**PLANNING AND ZONING COMMISSION
REGULAR MEETING AGENDA
MONDAY, MAY 24, 2021, 7:00 PM
SENIOR CENTER GREAT ROOM, 40 MAPLE ST, ELLINGTON, CT**

1. Z202101 - Ellington Enterprises, owner/applicant, pursuant to Section 4.1 of the Ellington Zoning Regulations request for a Special Permit and Site Plan Modification for the construction of a 9,600 sf building with wash bay at 77 Meadow Brook Road, APN 091-009- 0000 in an I - Industrial Zone.

I have reviewed the plans and calculations for the rear building and parking lot improvements at 77 Meadow Brook Road. The plans by Gardner & Peterson include 5 sheets dated 4/21/21. The Stormwater Management Report is dated 4/29/21. My comments are as follows:

I have reviewed the plans and calculations for Sunset Valley Farms at 55 Kreyszig Rd & Griswold Rd. The plans by Design Professionals include 5 sheets dated 4/23/21 and 2 sheets dated 2/12/21. The Drainage Narrative is also dated 4/23/21. My comments are as follows:

**IMPROVEMENT LOCATION SURVEY
EROSION & SEDIMENT CONTROL PLAN
ELLINGTON ENTERPRISES, LLC
APN: 091-009-0000 & 105-002-0001
77 MEADOW BROOK ROAD
ELLINGTON, CONNECTICUT**

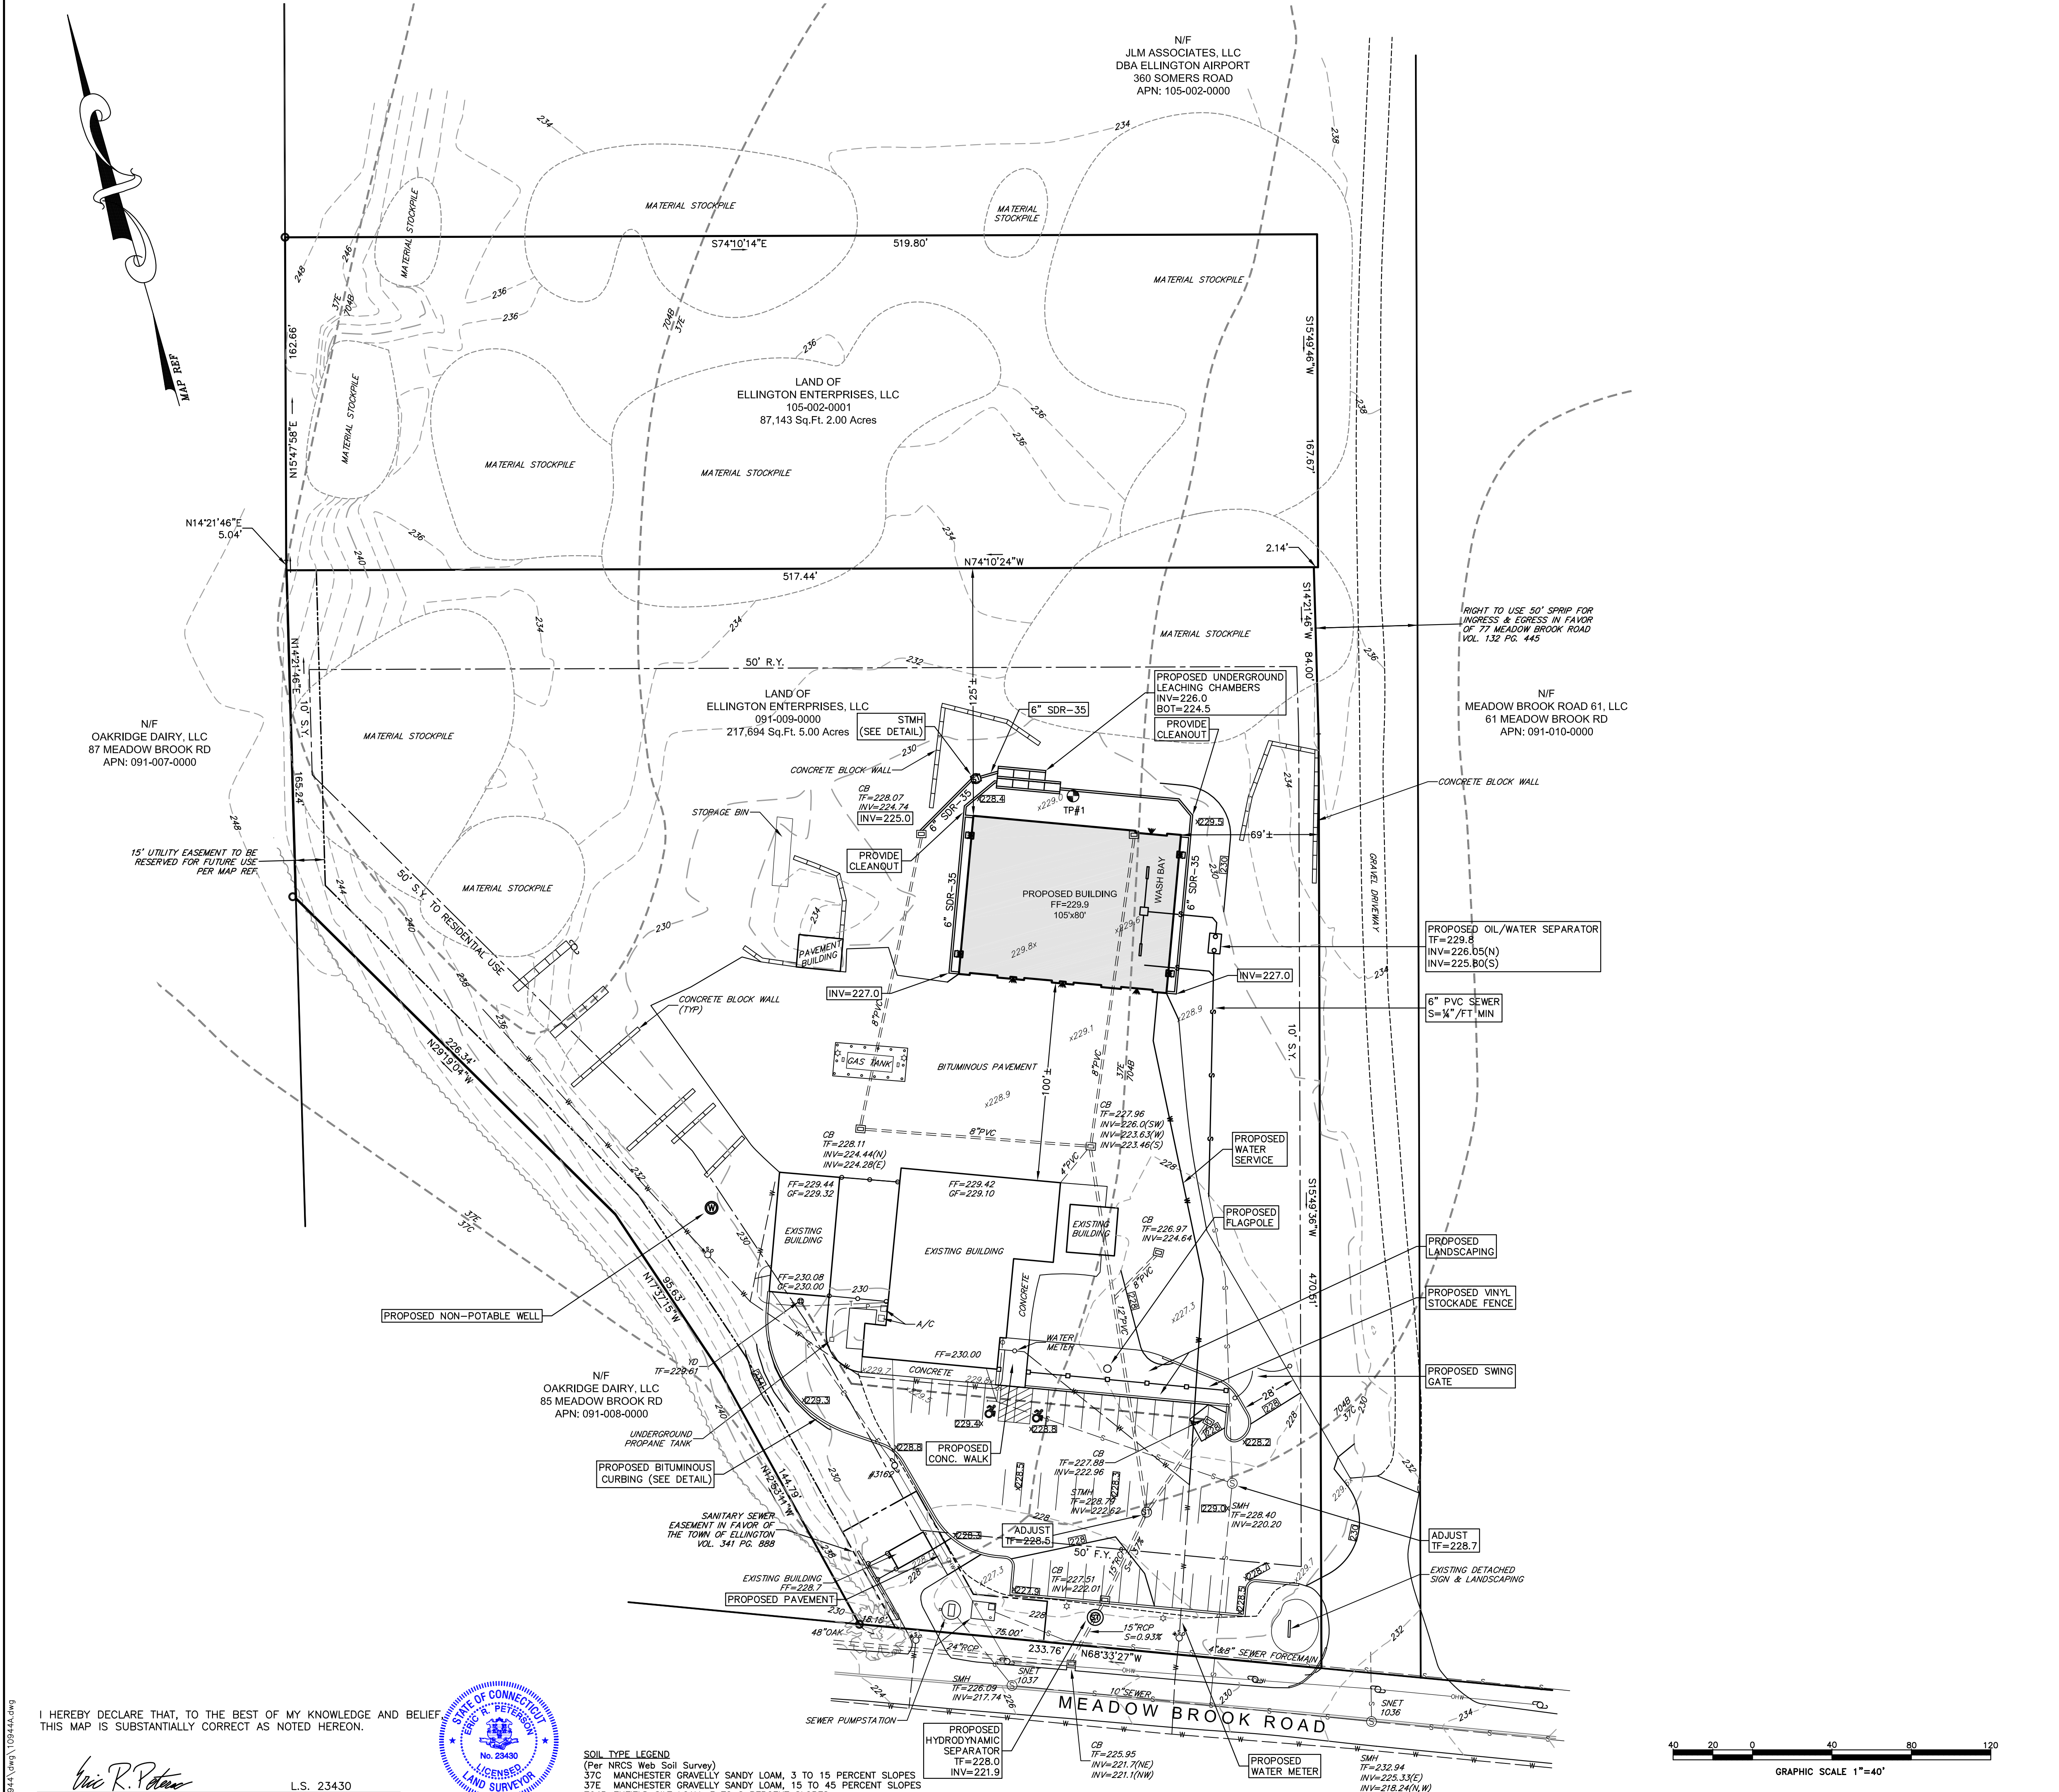
3. An erosion control plan should be provided indicating the location of silt fence, silt sacks and the construction entrance shown on sheet 4.
4. A separate water meter will be required for the new building. If this is to be located outside the building, note the location on the plans.

BY	SCALE	DATE	SHEET NO.	MAP NO.
E.R.P.	1"=40'	04-21-2021	2 OF 5	10944 A

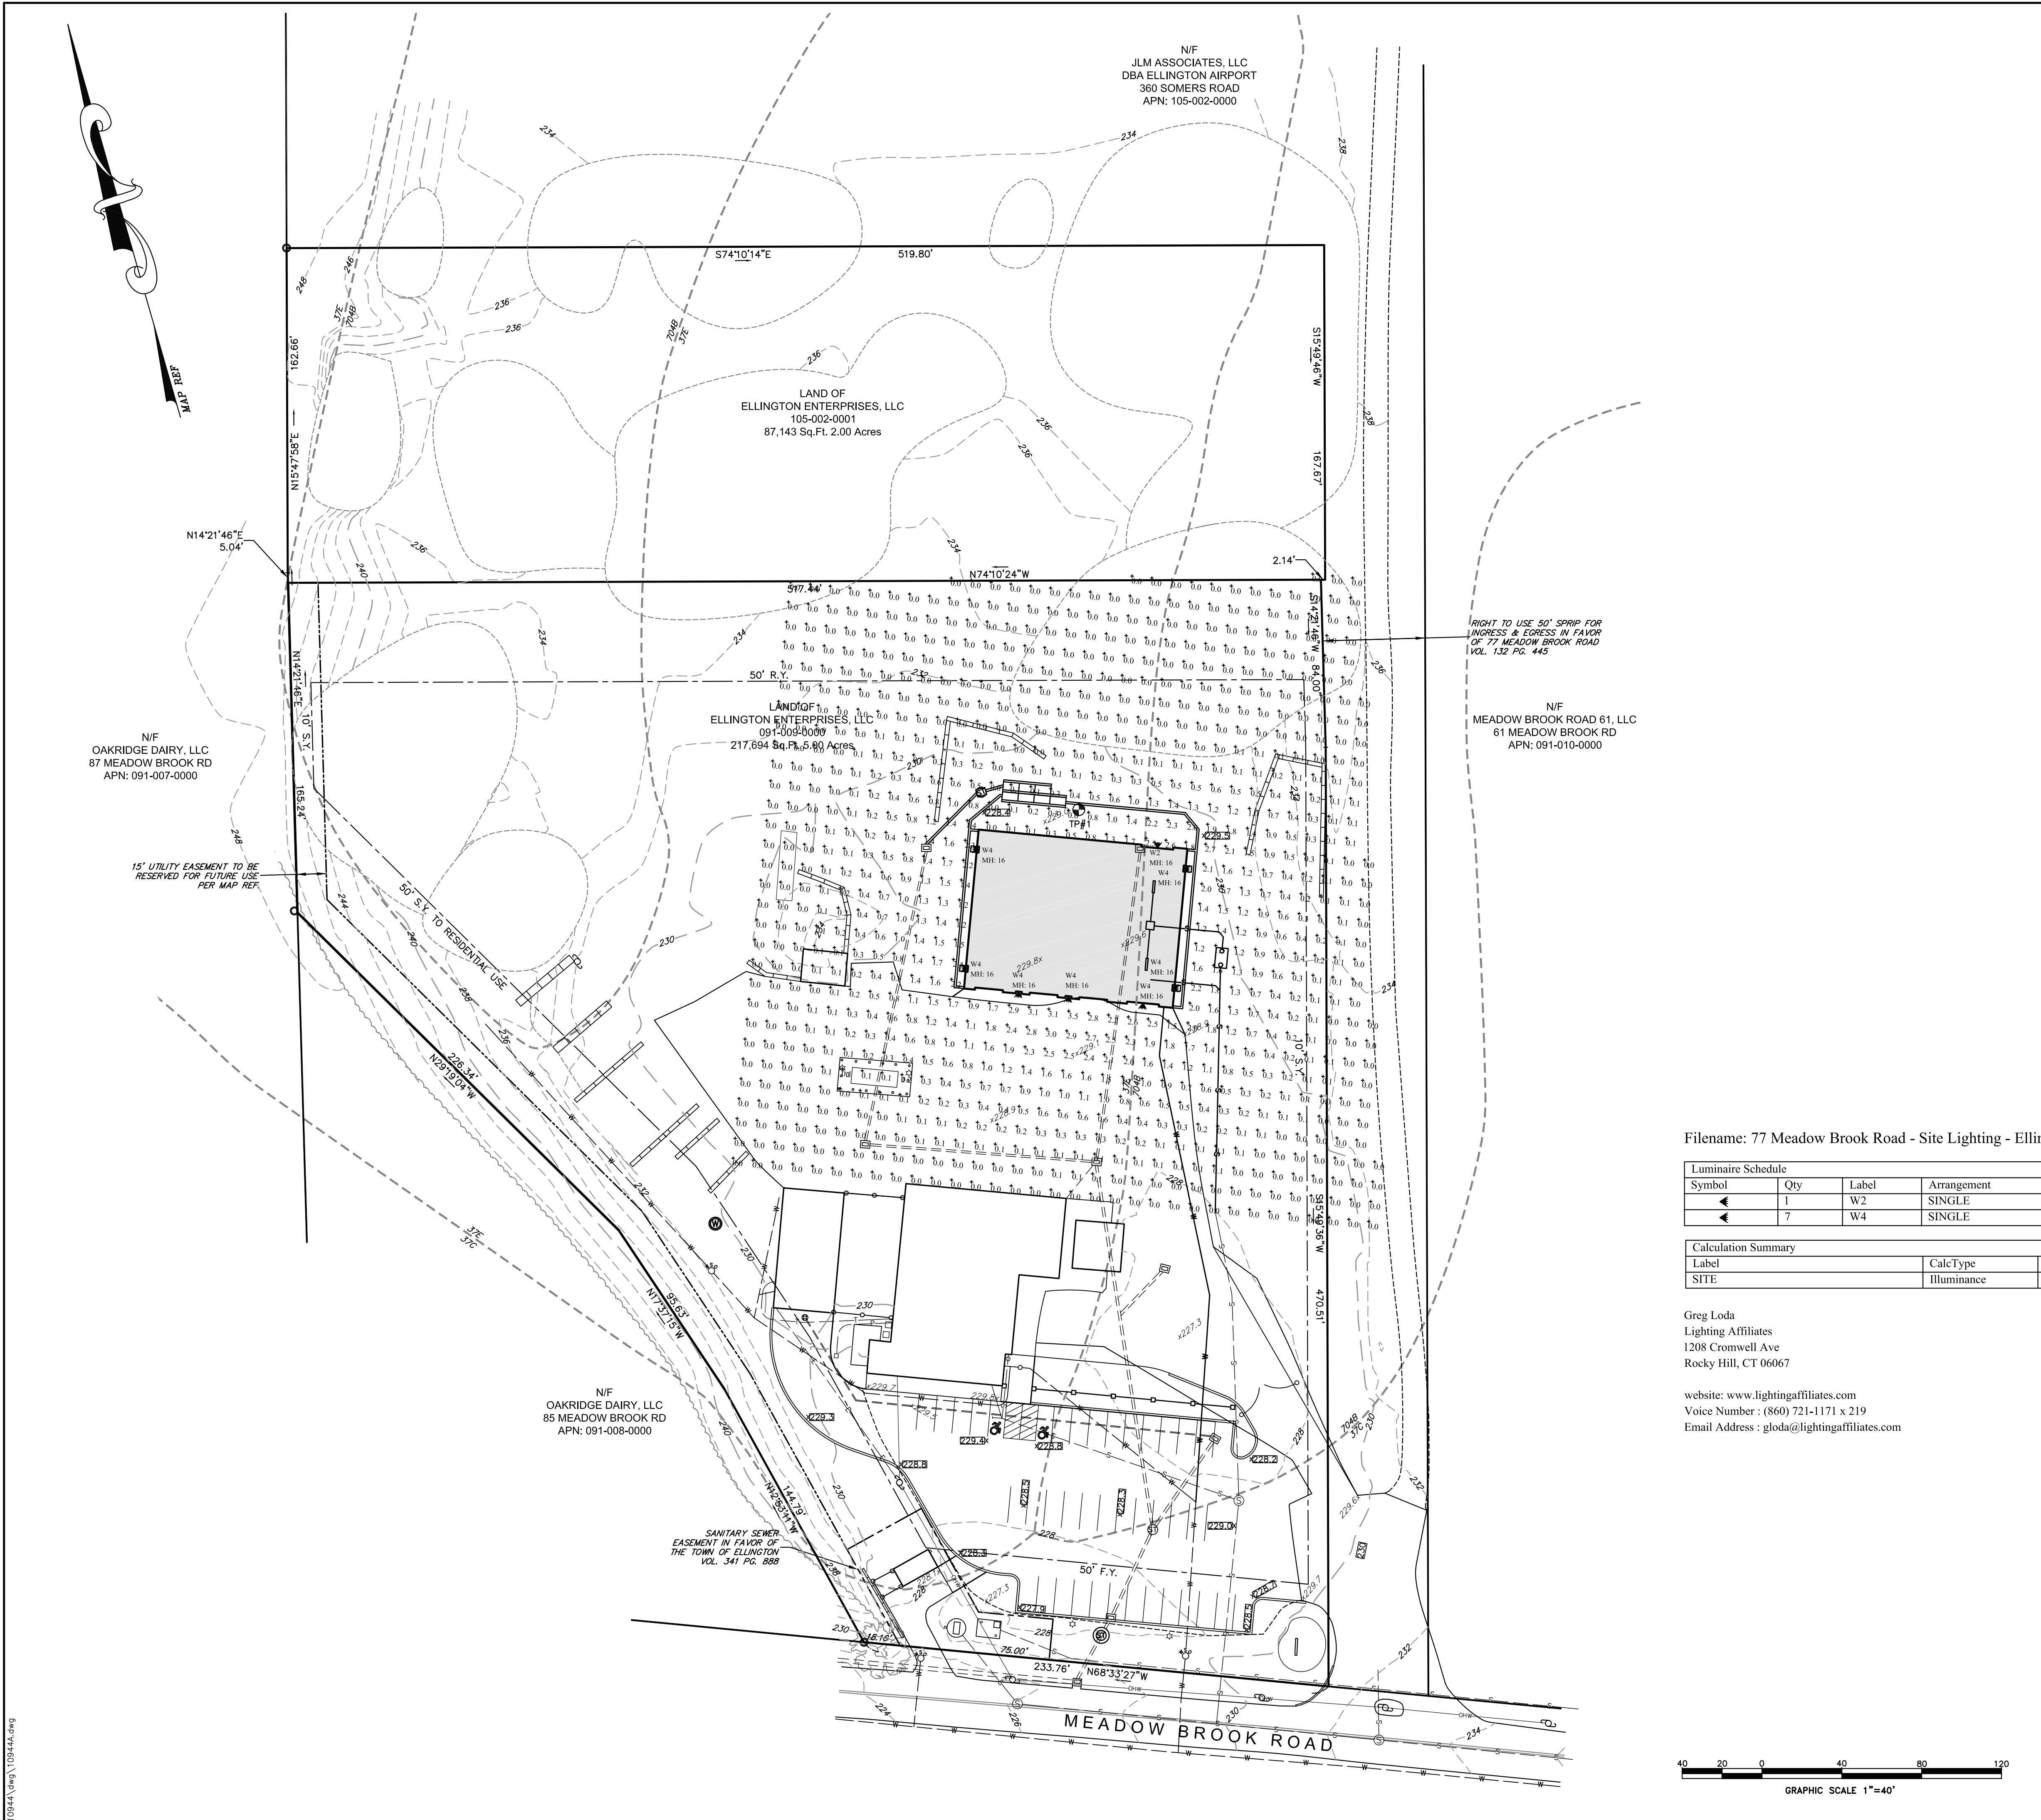
1. There is an existing catch basin within the area of the new building that is called to be removed. Plan should also note that the 8" PVC outlet pipe will be capped outside the building footprint.

2. The wash bay includes a second overhead door to the rear of the site. The surface around the back side of the building is not paved. I spoke to the engineer who indicated the rear door would not be used often so they did not propose additional pavement around the building. The plans indicate this area will be regraded so plans should indicate how this area will be restored to prevent erosion.

HYDRODYNAMIC SEPARATOR REQUIREMENTS

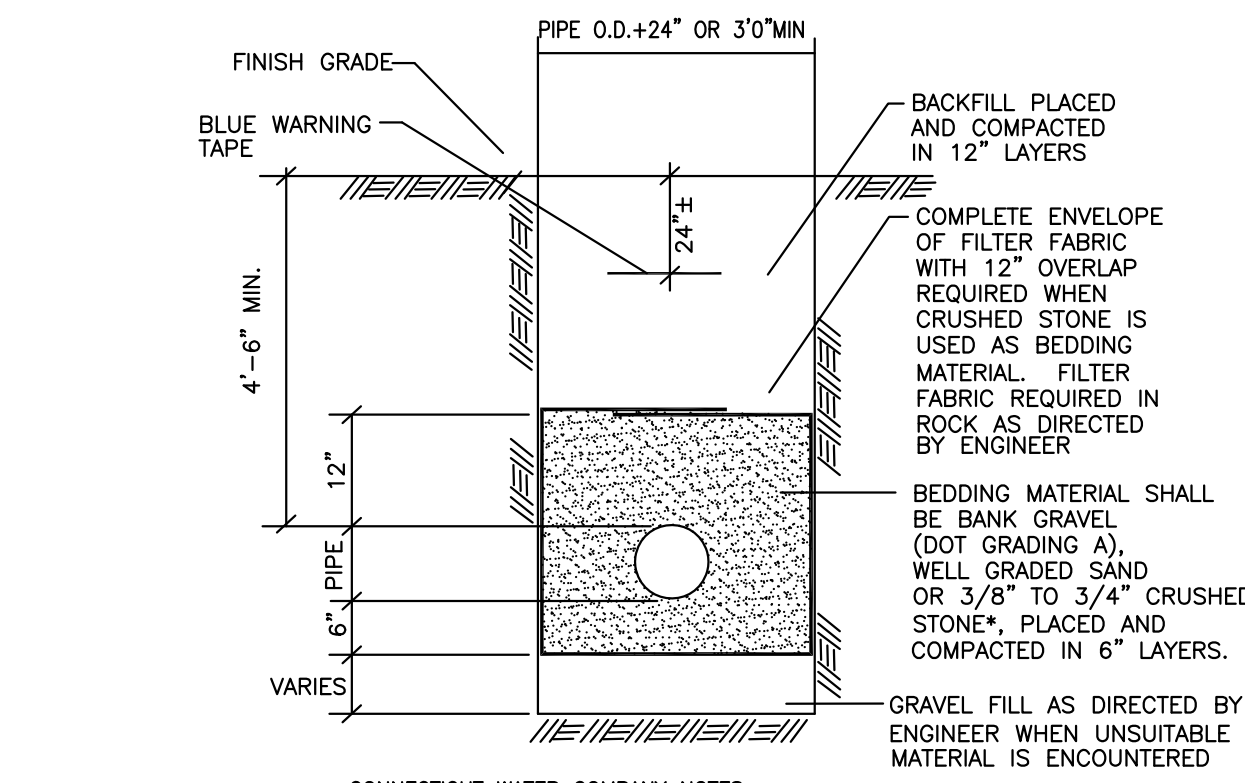
7. A hydrodynamic separator is proposed to improve water quality prior to connection to the municipal system. As noted on the sheet 5, shop drawings should be submitted to my office for review prior to fabrication.

SAND & OIL WATER SEPARATOR

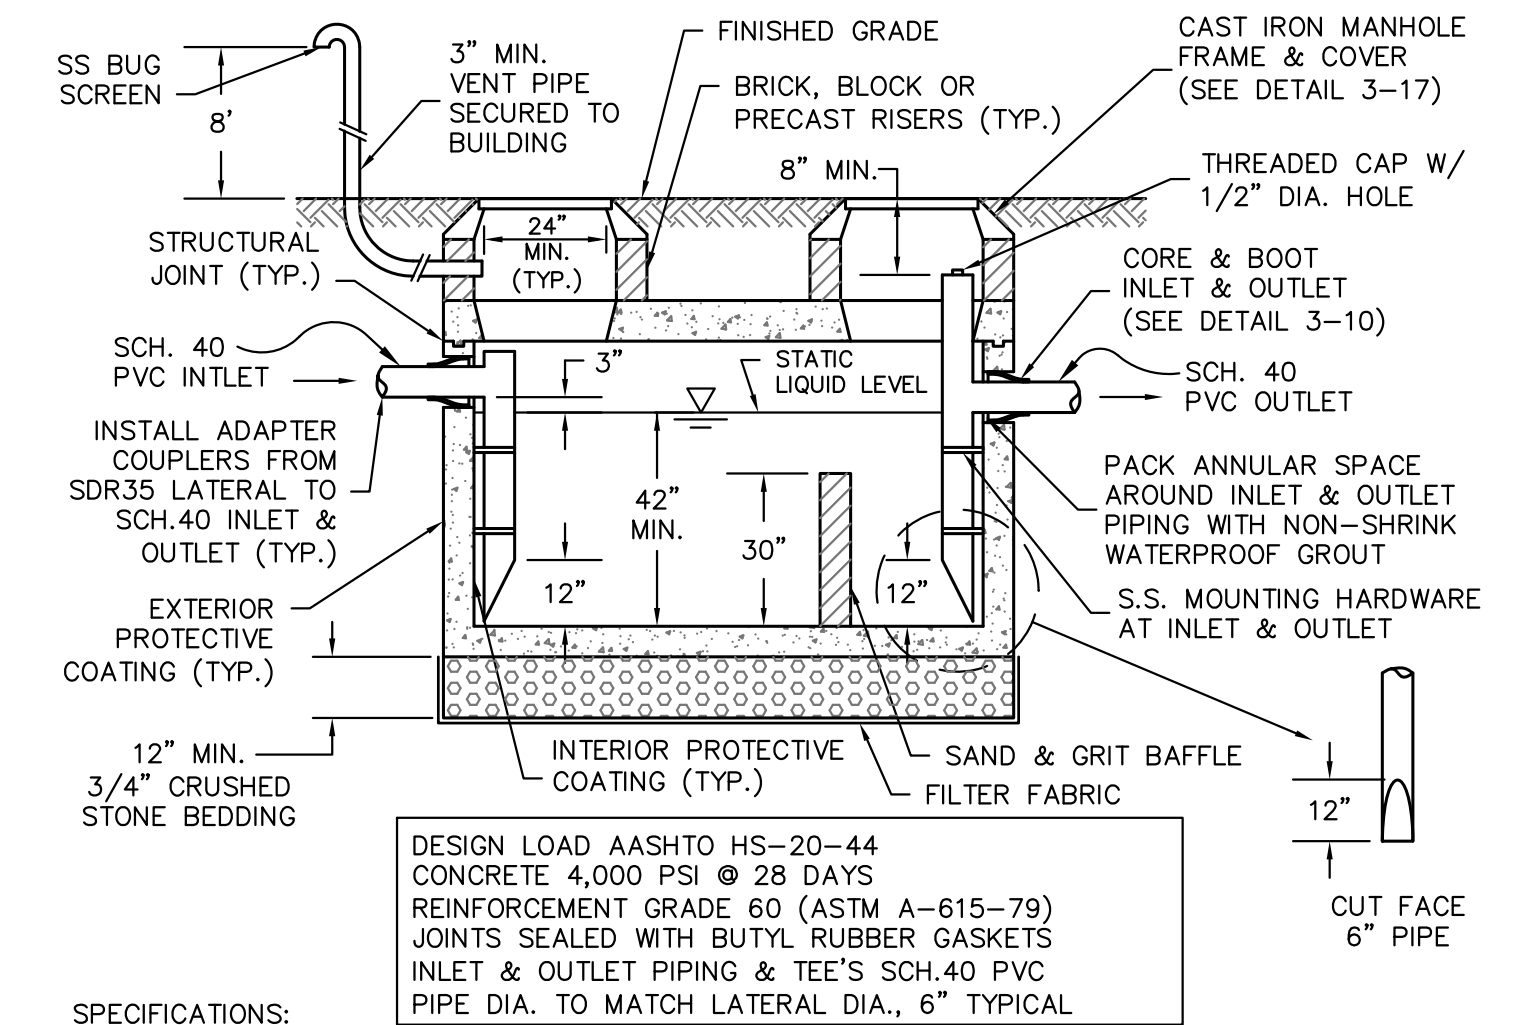
5. The sand & oil water separator detail on sheet 5 references other details that are not included in the plan. These details should be added or the references removed.
